**Davis Hall, Ground Floor Renovations**

**Project Number: SCSU-2023-02**

**ADDENDUM NO. 2**

**April 28, 2023**

REVISION: 1  
SHEET: MD1.01  
SCALE: 1/8" = 1'

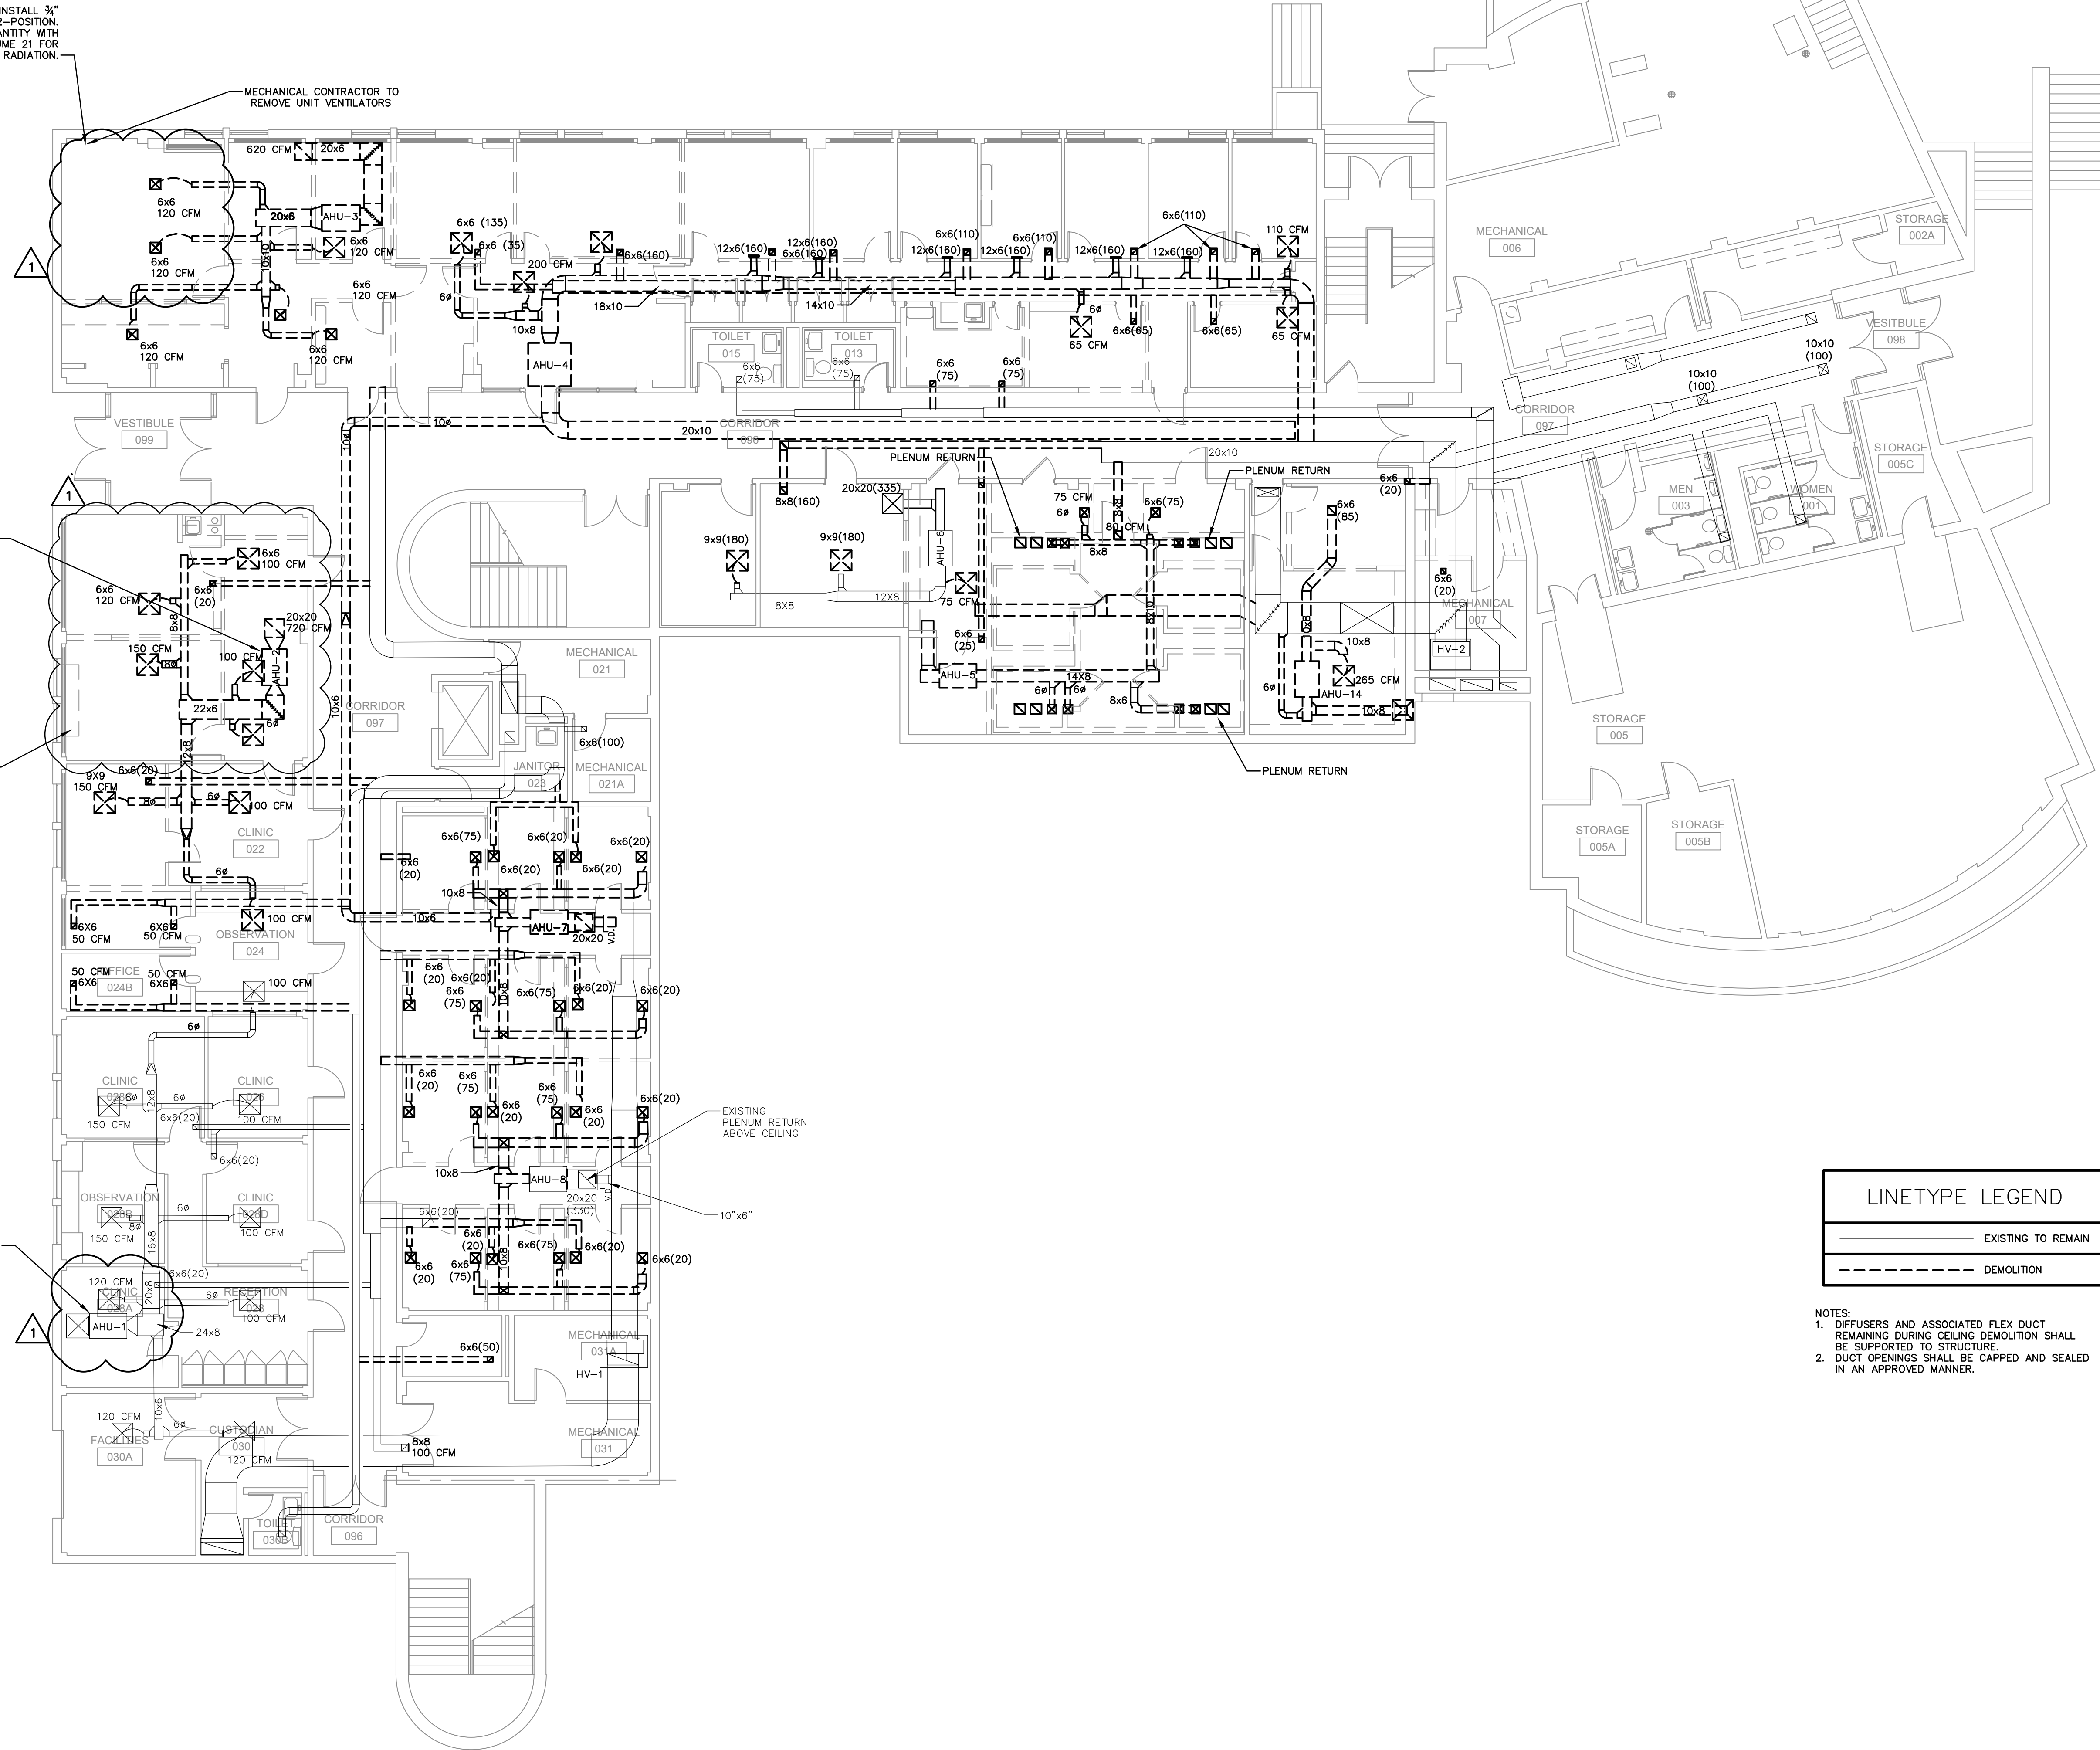
**Item 1 – DRAWING MD1.01, MECHANICAL DEMOLITION:**

Contractor to remove unit ventilator in rooms 019A and 020.

**Item 2 – DRAWINGS MD1.01 & M1.01, BASEBOARD RADIATION MODIFICATIONS:**

Contractor to remove existing pneumatic baseboard radiation control valves and install new electronic valves (provided by Automated Logic) along all exterior rooms utilizing baseboard radiation. Assume 21 valves. Install new baseboard radiation along outside walls in rooms 019A, 020, 025, 025B, 025D, and 027. Connect to existing hydronic loop. Install new control valves (provided by Automated Logic) as required. New thermostats (provided by Automated Logic) to be installed in all rooms with baseboard radiation as noted on revised drawings.

**Item 3 – DRAWING MD1.01, EXISTING AHU CONTROLS:**

Automated Logic to upgrade controls for AHU-1, 6, 8, and two (2) H&V units. The mechanical contractor shall install electronic hot and chilled water coil control valves (provided by Automated Logic).

CONTRACTOR TO CUT IN AND INSTALL 3/4" BELIMO VALVE, 2-WAY, 2-POSITION. COORDINATE LOCATION AND QUANTITY WITH AUTOMATED LOGIC. ASSUME 21 FOR BASEBOARD RADIATION.

MECHANICAL CONTRACTOR TO REMOVE UNIT VENTILATORS

AUTOMATED LOGIC TO PROVIDE VALVE FOR NEW AHU UNITS. MECHANICAL CONTRACTOR TO INSTALL.

REMOVE UNIT VENTILATOR. MECHANICAL CONTRACTOR TO EXTEND BASEBOARD RADIATION ALONG OUTSIDE WALL.

AUTOMATED LOGIC TO UPGRADE CONTROLS FOR AHU-1, 6, 8, TWO H&V UNITS. MECHANICAL CONTRACTOR TO INSTALL VALVES. AUTOMATED LOGIC TO PROVIDE VALVES

SHEET:  
M1.02

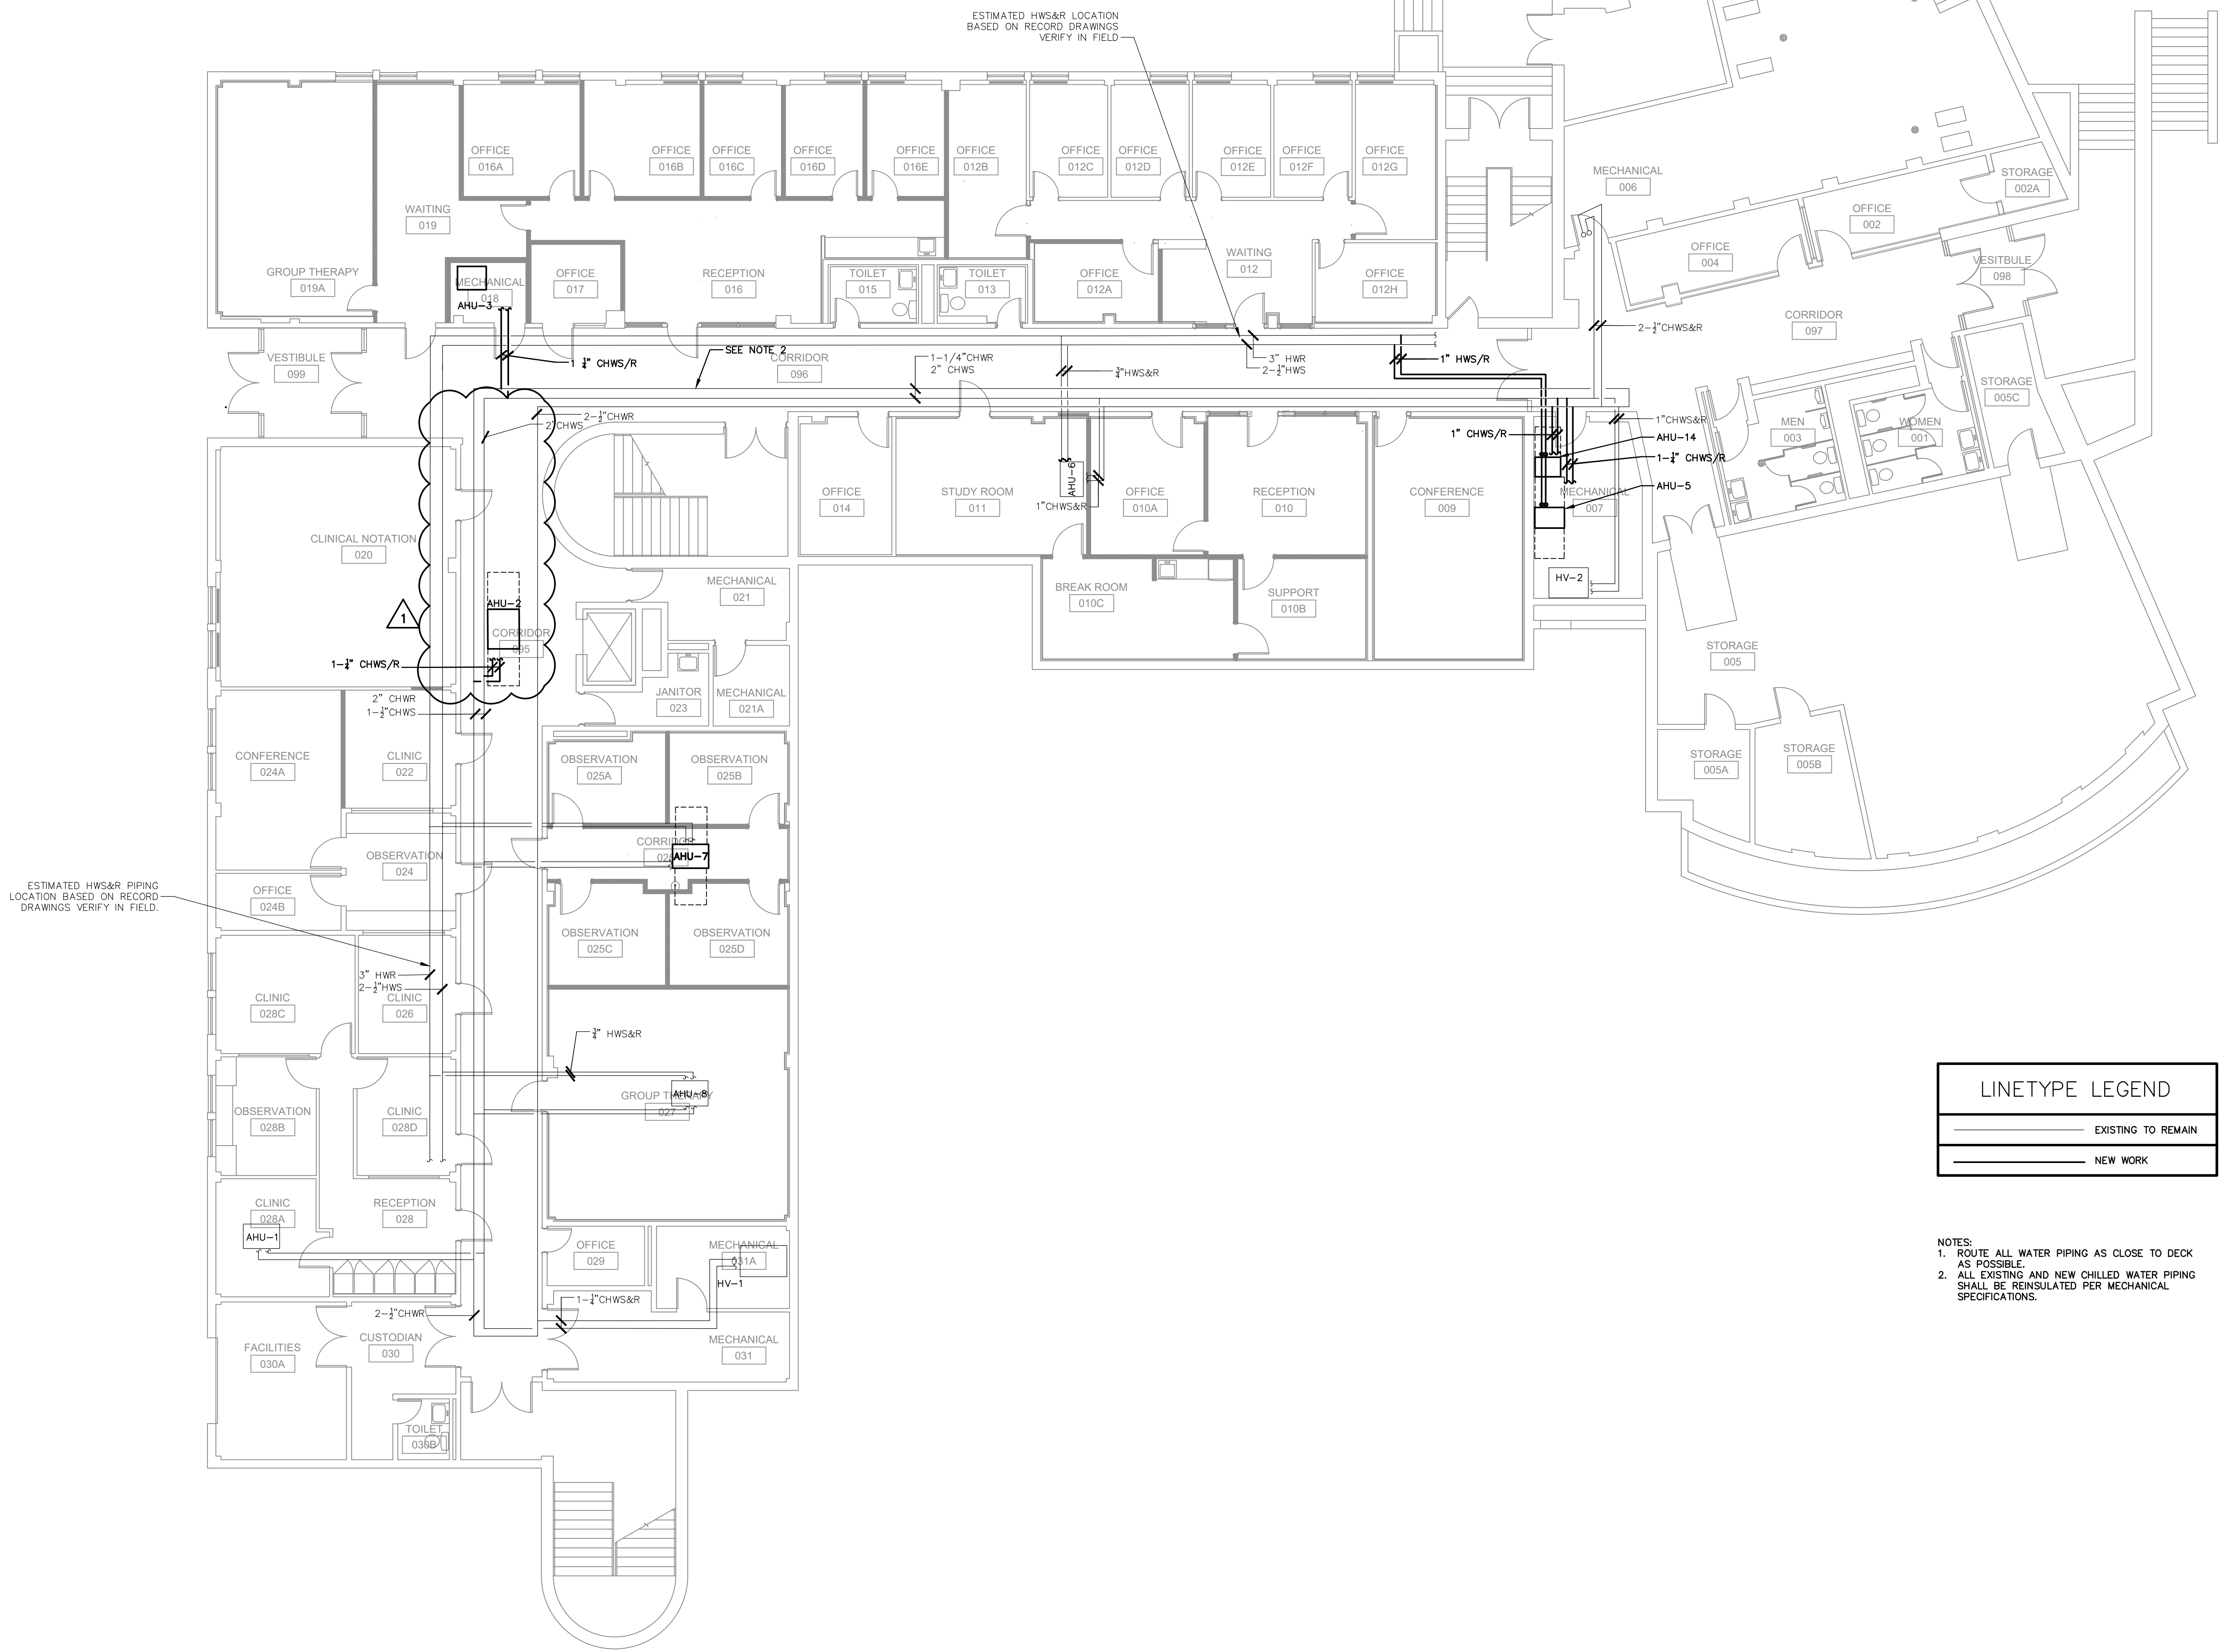
**Item 6 – DRAWING M1.02, CHILLED WATER PIPING:**

Relocation of chilled water lines to AHU-2 to Corridor 095 between elevator and Clinical Notation 020. See revised M1.02 drawing, attached, for new chilled water routing.
